ARCHITECT'S ADDENDUM

Addendum Number: 01

RE: EAHS 2026 Secured Entrance

Subject: Addendum 01 to the Construction Documents for the East Aurora High School 2026 Secured Entrance Project.

3 AREA B - ROOF PLAN
1/8" = 1'-0"

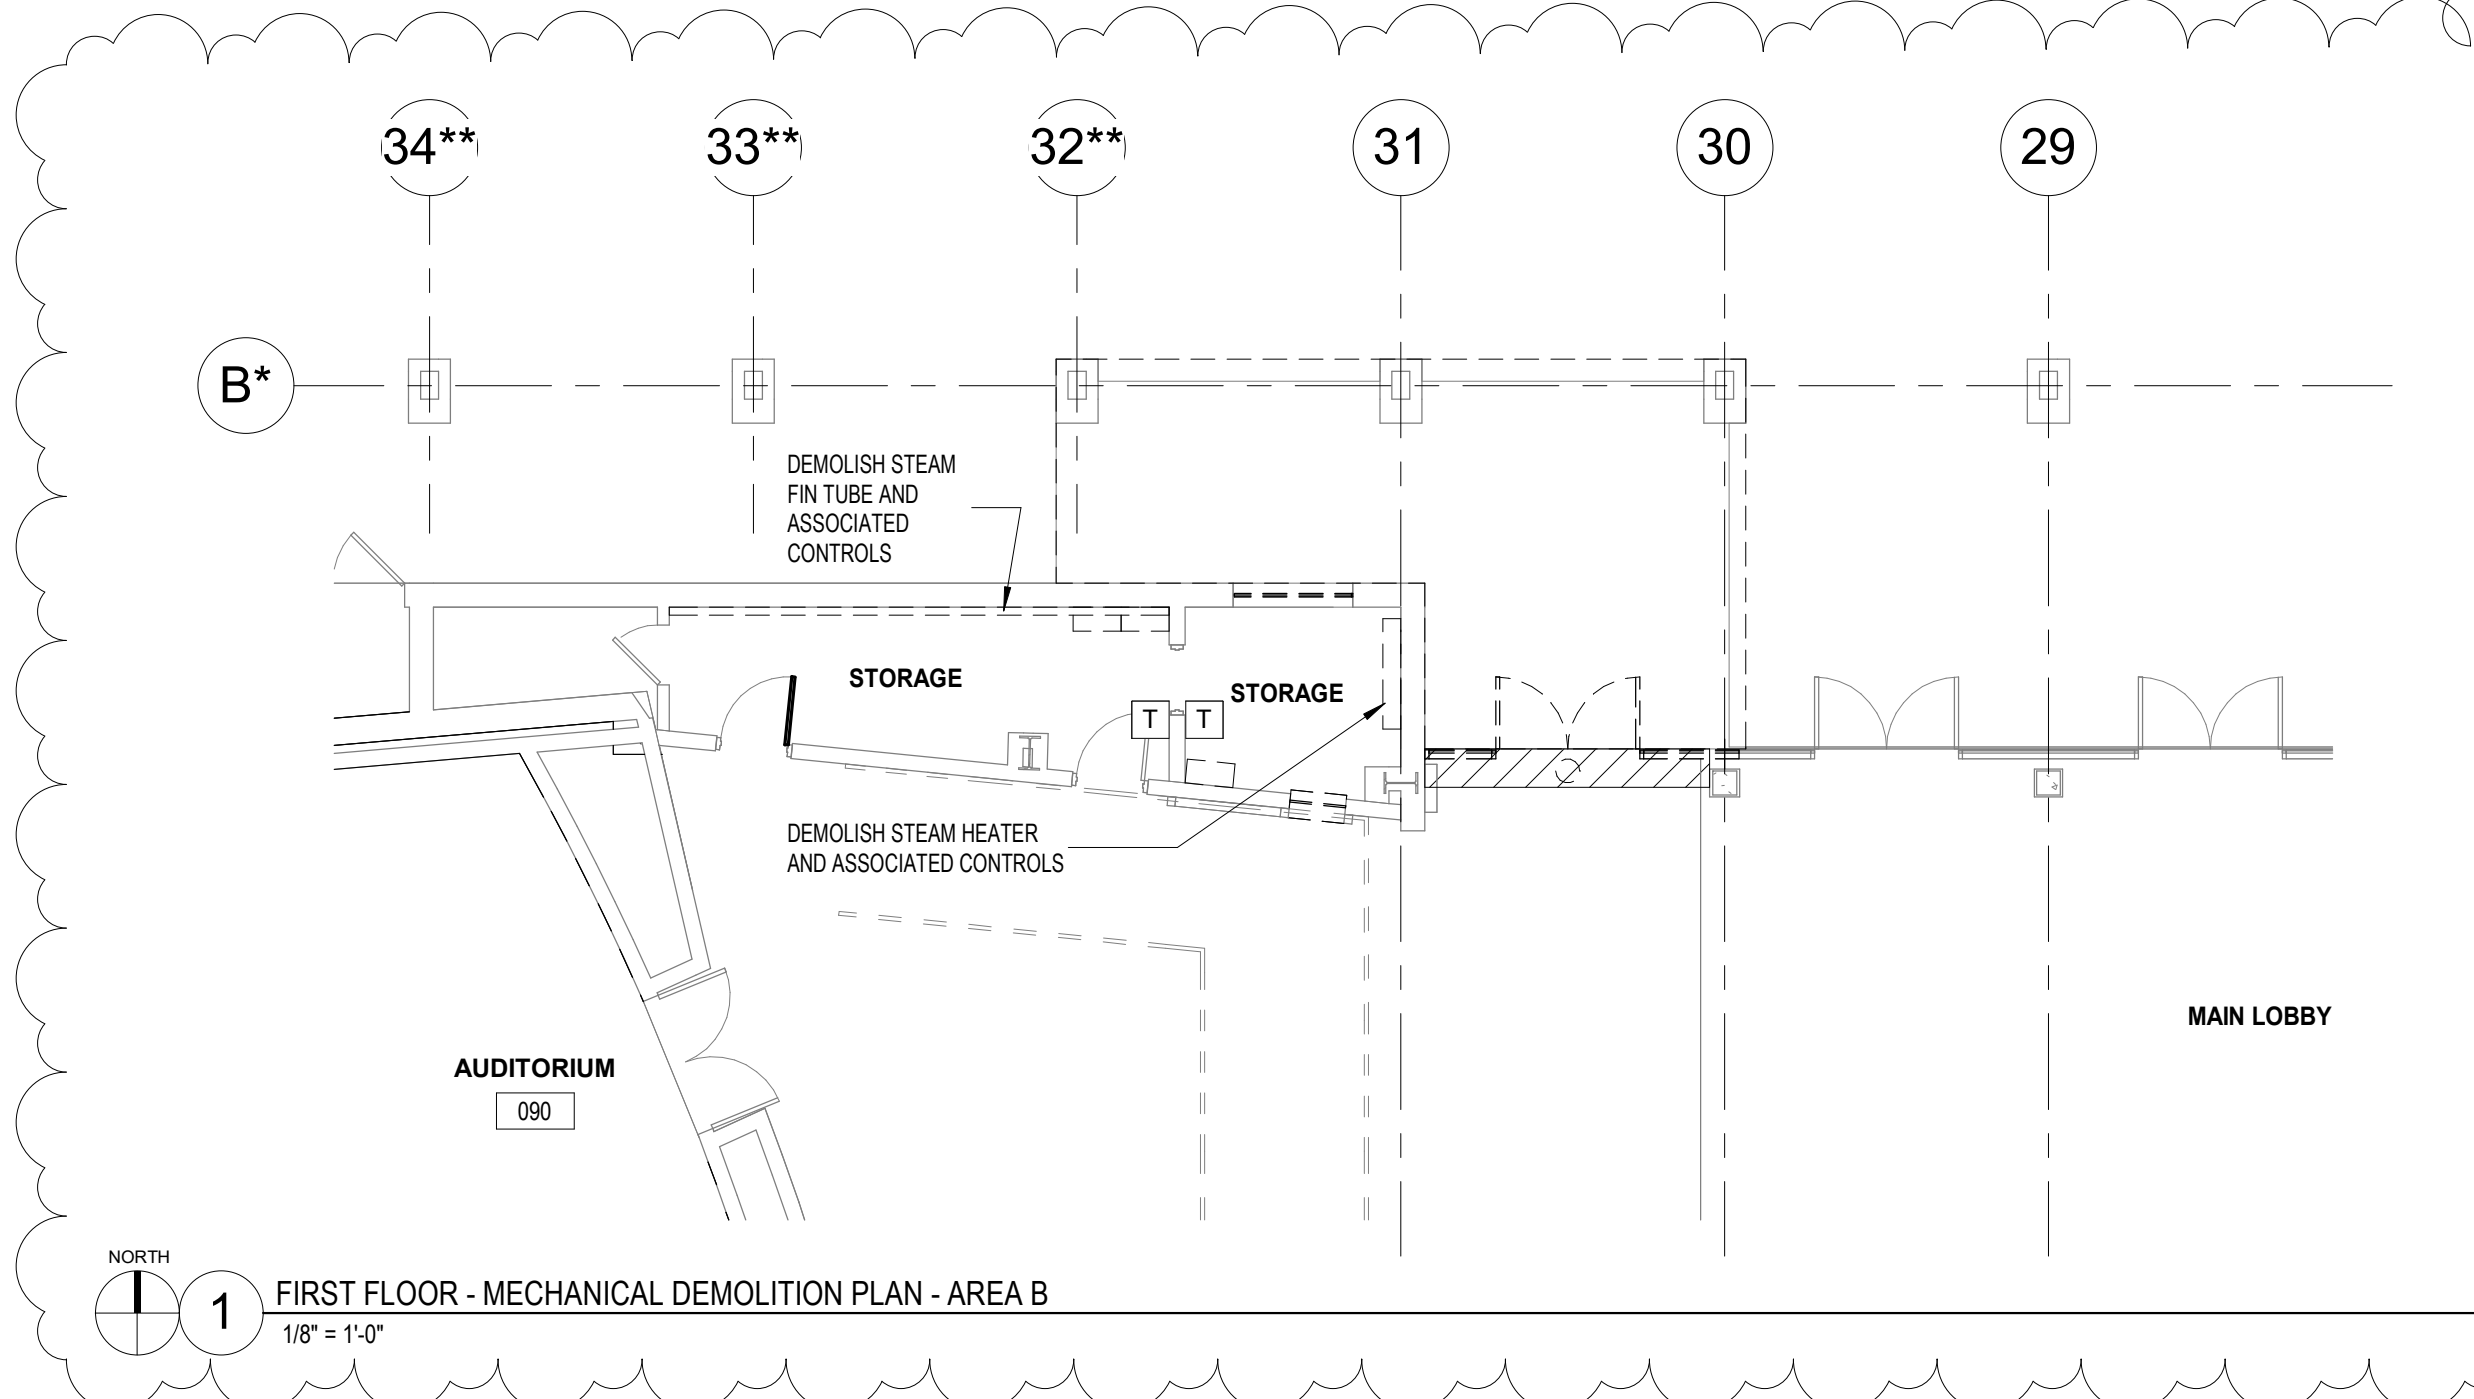
- 3) M1.00 – B – PARTIAL MECHANICAL FIRST FLOOR PLANS – AREA B
 - a) Relocated EF-2 to be within the Security Room.
 - b) Add door grille to existing door.
 - c) Relocated FT-2 within Security Room.
 - d) Revised FT-2 callout to FT-1 on Detail 2/M1.00-B.
 - e) Updated demolition plan note, "DEMOLISH STEAM FIN TUBE AND ASSOCIATED CONTROLS".
 - f) Updated demolition plan note, "DEMOLISH STEAM HEATER AND ASSOCIATED CONTROLS".
 - g) Add pipe curb location to Area B Roof Plan 3/M1.00-B.

2 FIRST FLOOR - ELECTRICAL NEW WORK PLAN - AREA B
1/8" = 1'-0"

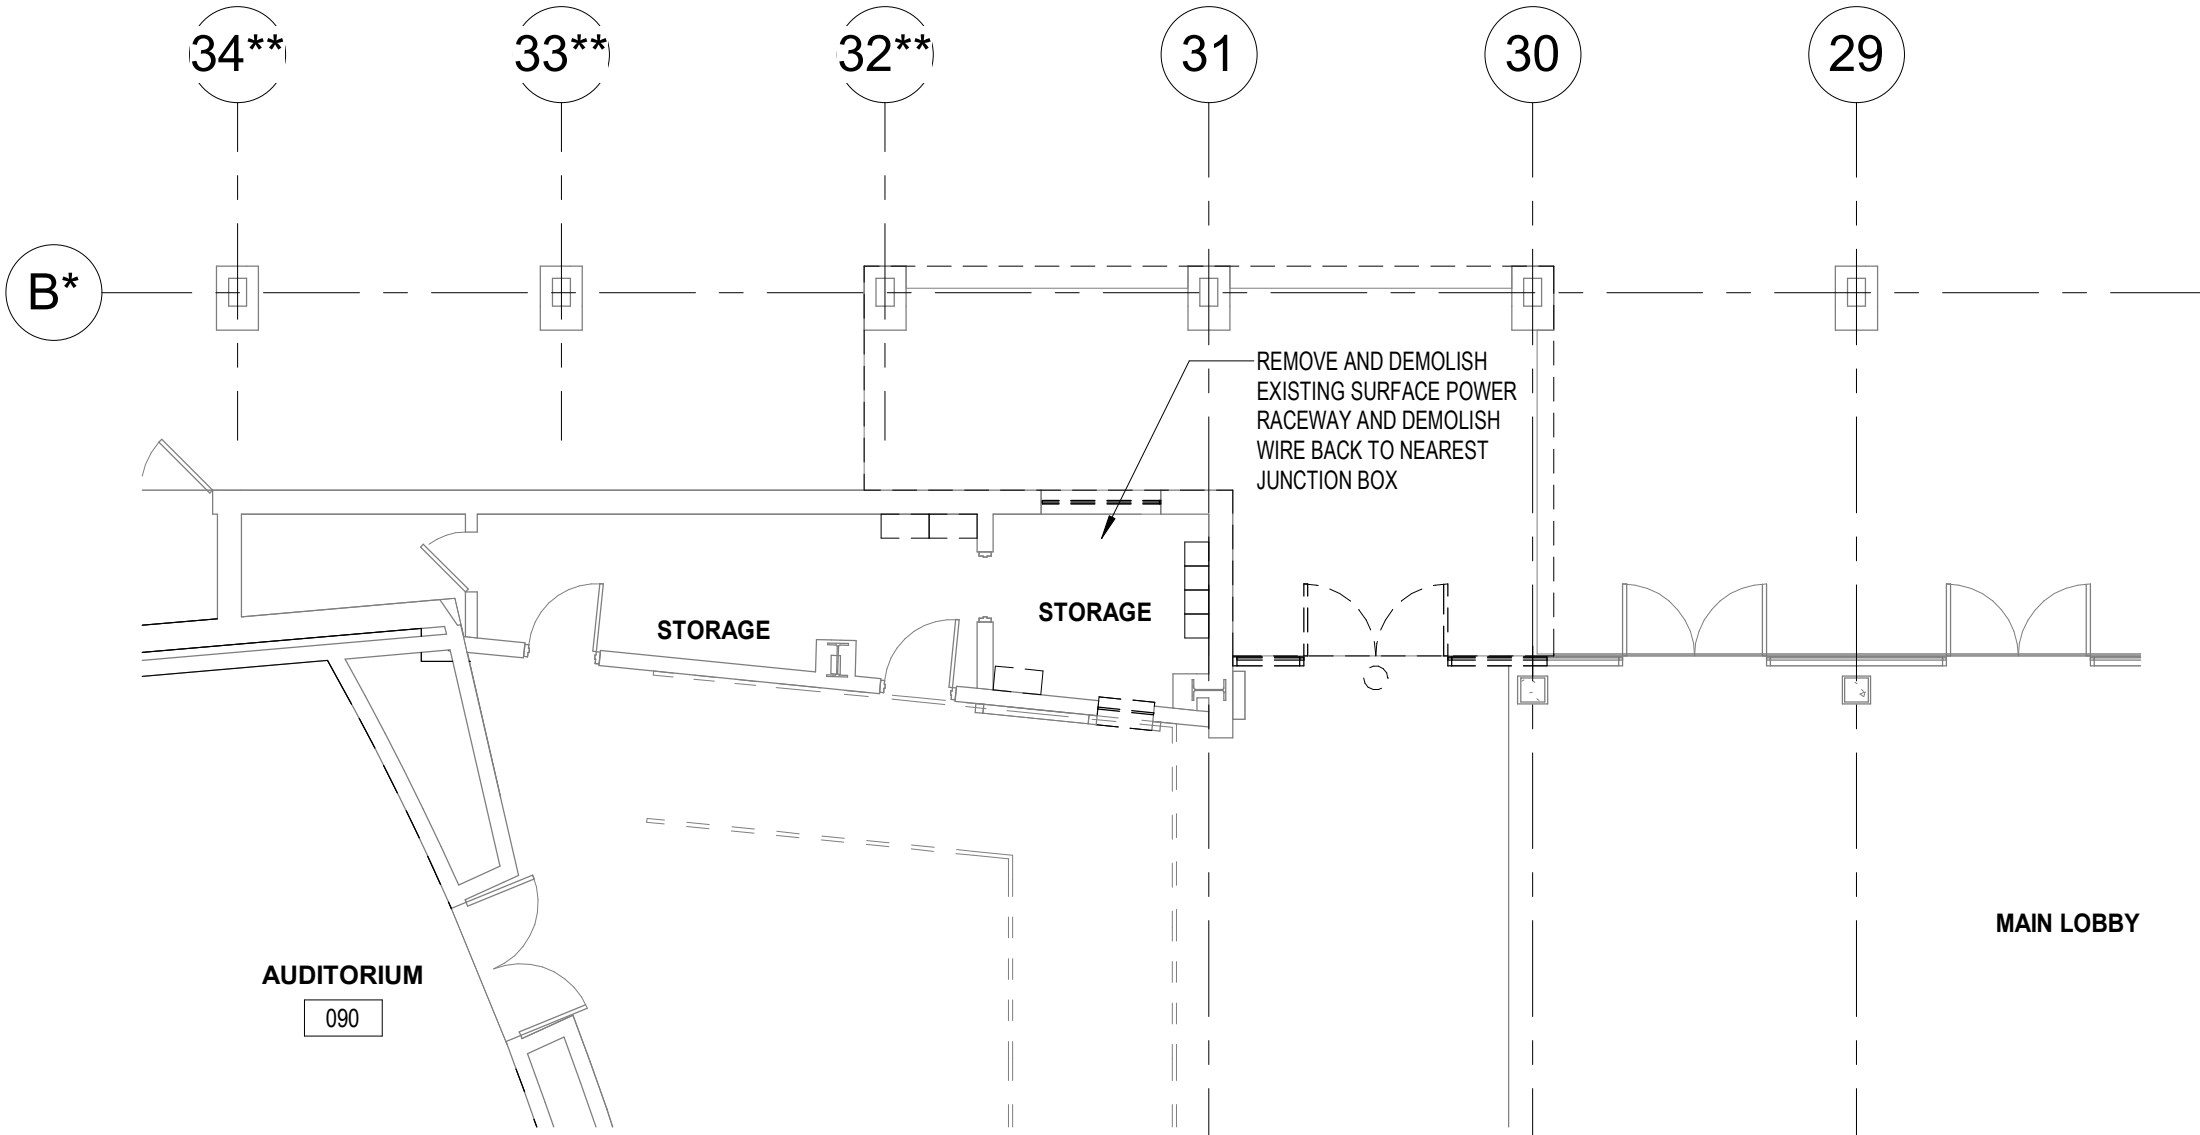
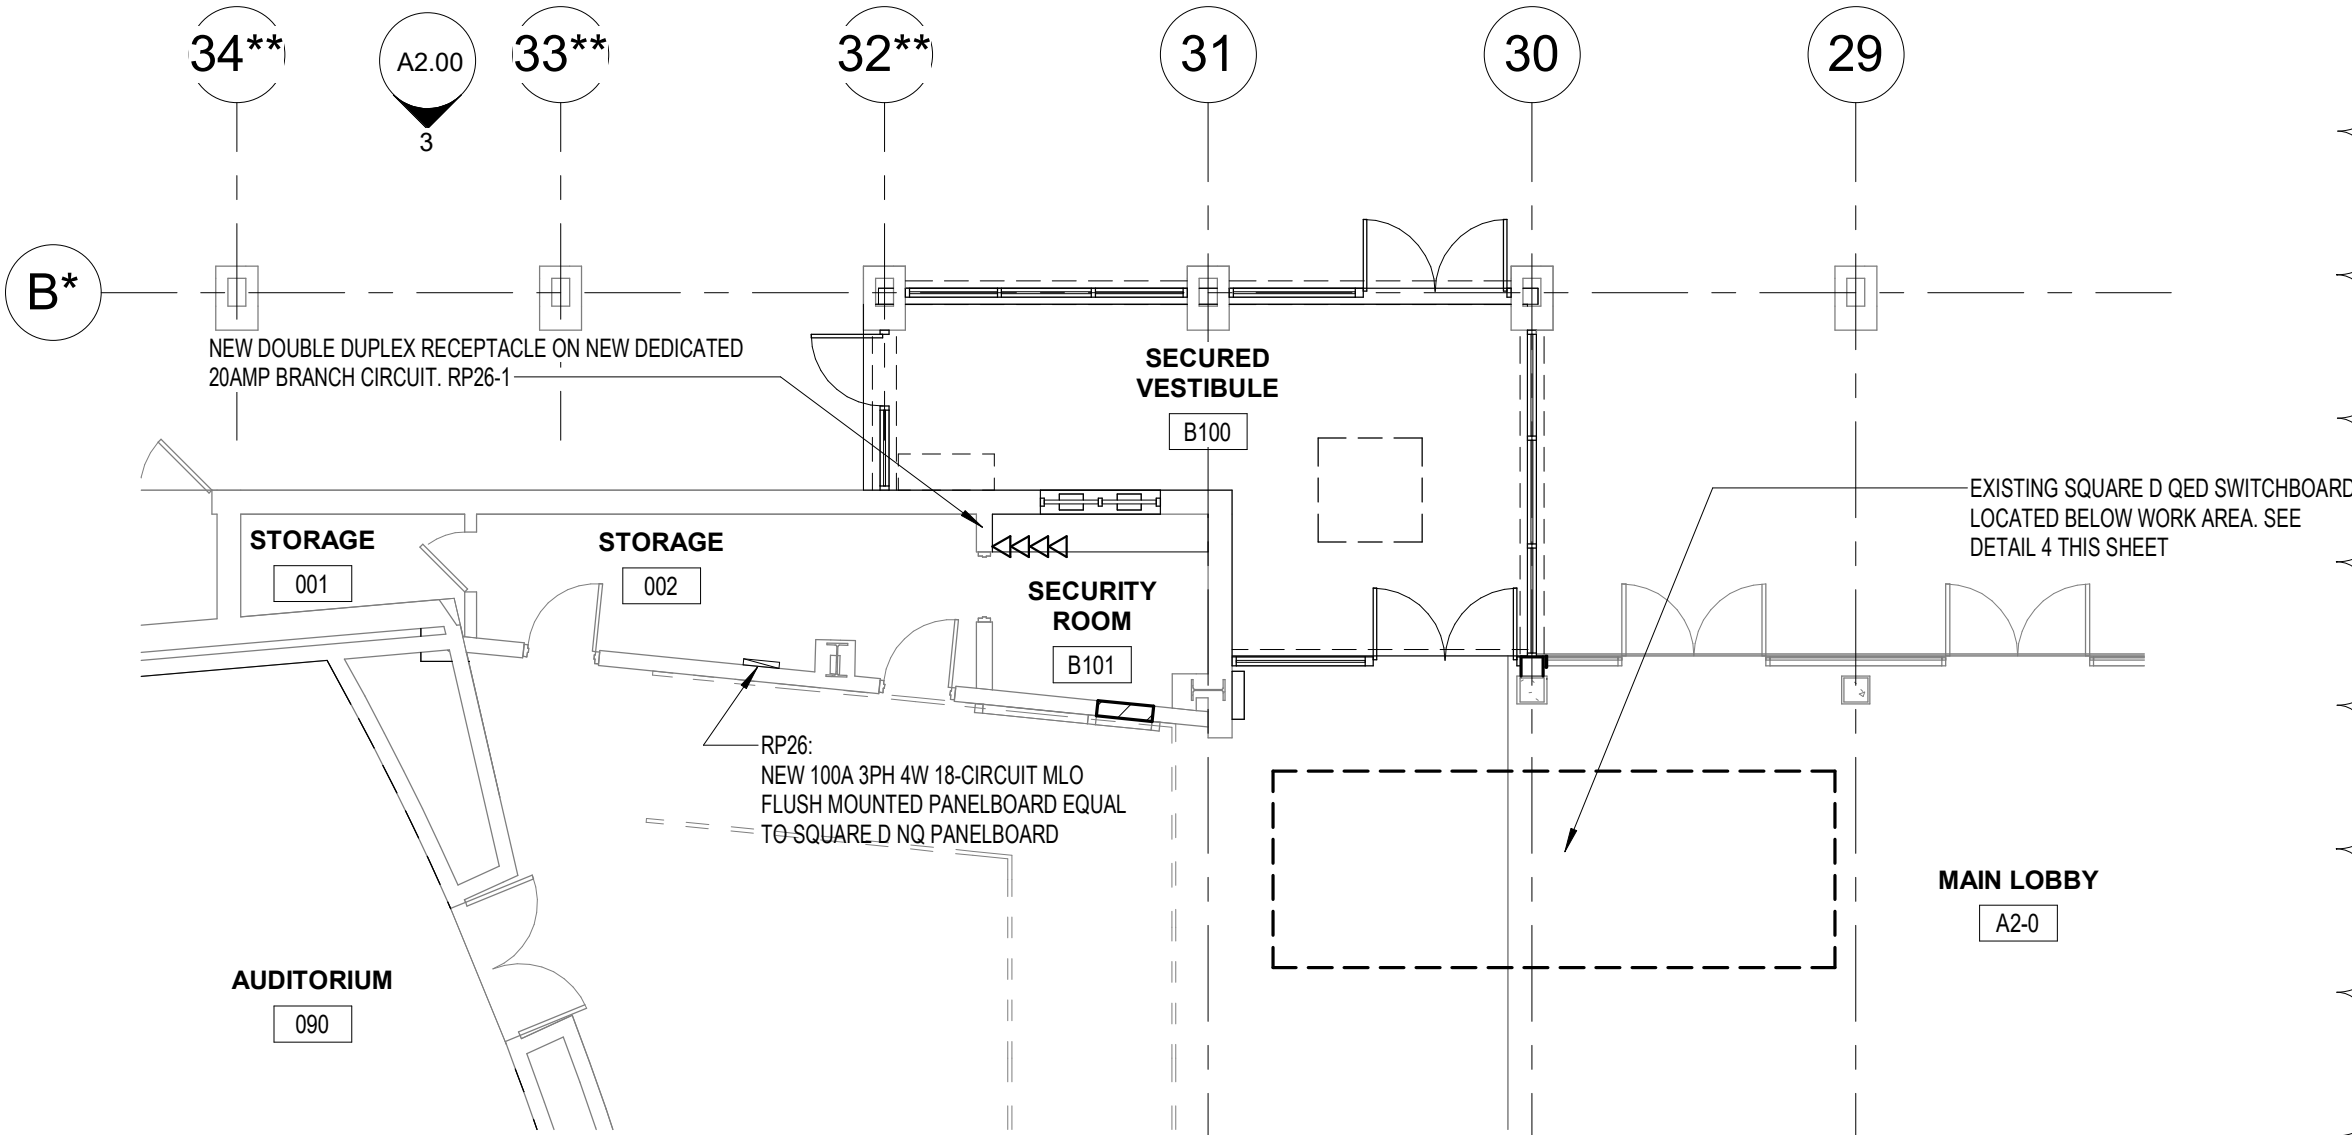
- 4) E1.00 – PARTIAL ELECTRICAL FIRST FLOOR PLANS – AREA B
 - a) Add (1) LITHONIA 2BLT4-40L-ADP-EZ1-LP835 lighting fixture
 - b) Remove (2) nLIGHT RPODU-DX-WH-G@ switch
 - c) Remove (2) LITHONIA BLWP4-48L-ADPT-EZ1-LP835-NLTAIR2-RES7
